**ZONING AMENDMENT,  
PLANNED UNIT DEVELOPMENT &  
SUBDIVISION STAFF REPORT**

**Date: October 2, 2003**

Brookview at Brookside Subdivision

# DRAINAGE SITE PLAN

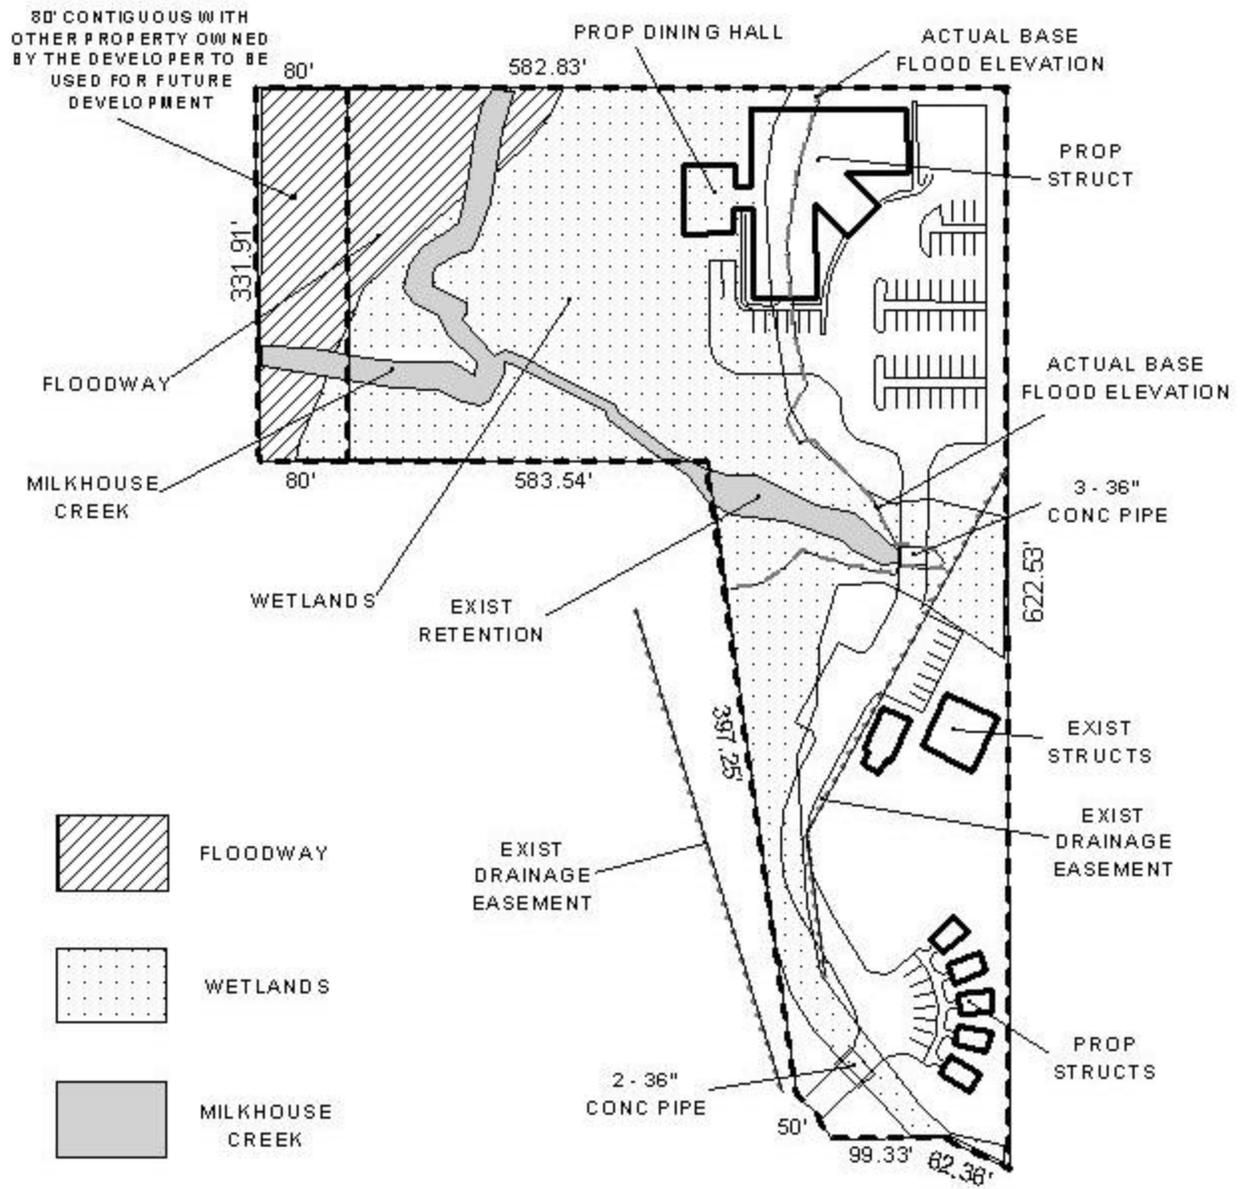
Recommend holdover. The applicant has initiated the clearing phase of construction without a permit and the site plan does not show existing contours as required by the Subdivision Regulations. The proposed development appears to encroach over a major drainage easement that conveys storm flows from a significant watershed to the East. In addition, it is the Engineering Department's understanding that the proposed site also

includes wetlands that are not shown on the plans. If this site is approved for development at all, significant changes may be required to comply with the Storm Water Ordinance.

*Information submitted by applicant indicates actual floodway and floodplain are shifted to the east where the new structures and parking are proposed. This further complicates development of this property. The proposed building and parking encroaches into the wetlands adjacent to Milkhouse Creek. As with all applications of this type complete compliance City of Mobile stormwater regulations (inc. FEMA) will be required.*

# DETAIL SITE PLAN

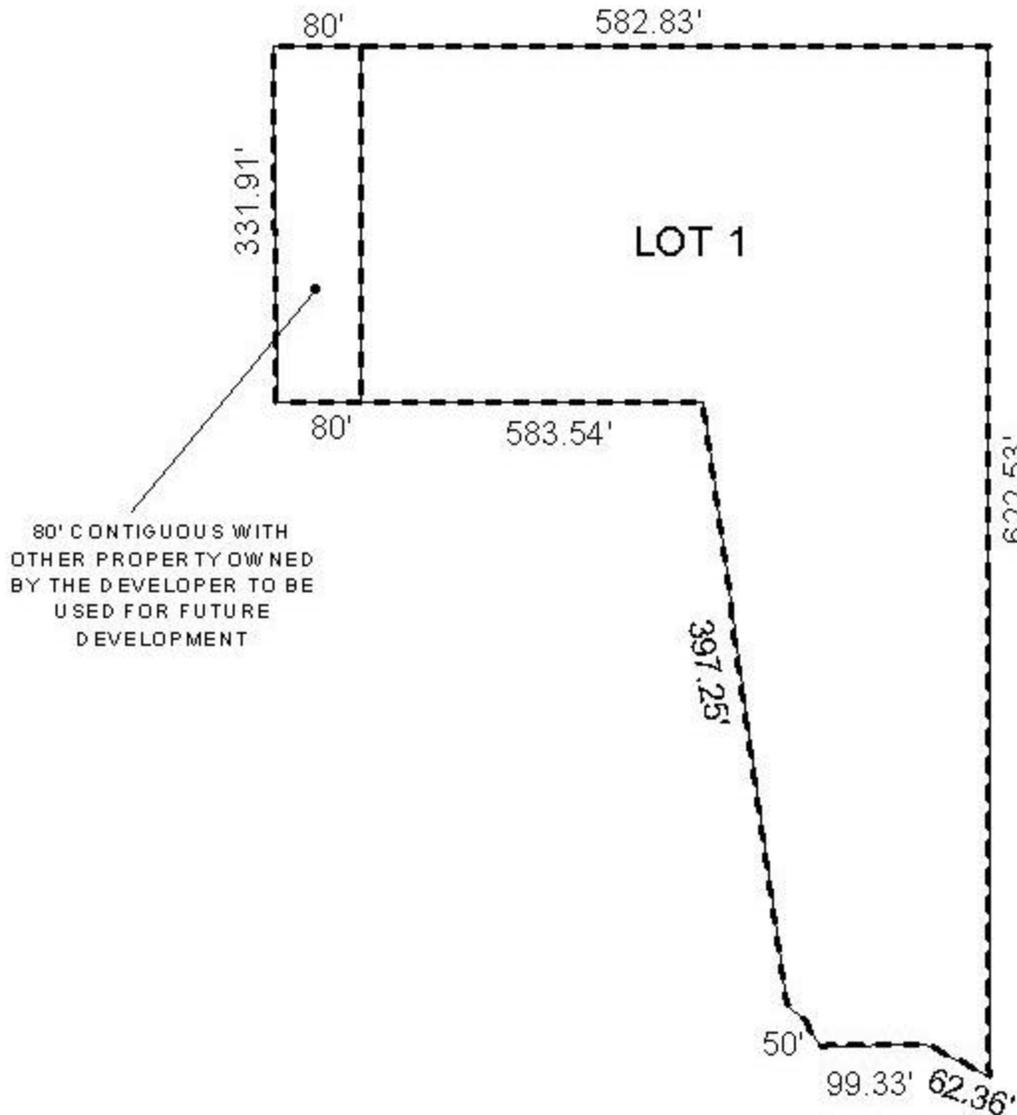
*The applicant has submitted a revised plan that illustrates contours, watercourses, wetlands, base flood elevation lines, and easements. Also shown on the plan is a note that the western 80-foot (which appears to be the balance of the property from which the lot is being taken) is “contiguous with other property owned by the developer to be used in future development.” The “other property owned by the developer” appears to be Lot 9 of Moss Creek, as referenced in the Engineering Comments above.*

*There are numerous problems associated with the proposed site plan. The plan illustrates that both the edge of the wetlands and the actual base flood elevation line are located well within the footprint of the proposed assisted living facility. Additionally, the entire dining hall, as well as some parking, are also within the wetlands. Planned Unit Development approval is site plan specific, and while minor modifications to the building footprint may be made, the Commission has consistently prohibited building construction in delineated wetlands, thus necessitating a complete redesign of the site plan.*

*Another issue is the bridge between the overall Pesnell Court site and the R-1 lot to the West. Any connection between lots, such as a bridge or driveway, would require PUD approval; PUD approval was not obtained for this bridge. Pesnell Court is zoned R-3 and is a high density development for the elderly; as part of the overall PUD approval for Pesnell Court, accessory uses such as a chapel, recreational center and assisted living were approved. Moss Creek Court is a single-family residential subdivision and direct access between Moss Creek and Pesnell Court would, in this case, be inappropriate.*

*In regard to the proposed subdivision, there is a note on the plat stating that there is “80’ contiguous with other property owned by the developer to be used in future development.” Approval of the subdivision as proposed would leave the 80’ parcel unaccounted for and essentially validate a land-locked metes and bounds parcel.*

**Rezoning:** *Based upon the preceding, this application is recommended for denial.*

**Planned Unit Development:** *Based upon the preceding, this application is recommended for denial.*

**Subdivision:** *Based upon the preceding, this application is recommended for denial for the following reason: 1) approval of the subdivision would not account for the 80’ parcel to the West; and 2) approval of the subdivision would validate a land-locked metes and bounds parcel.*
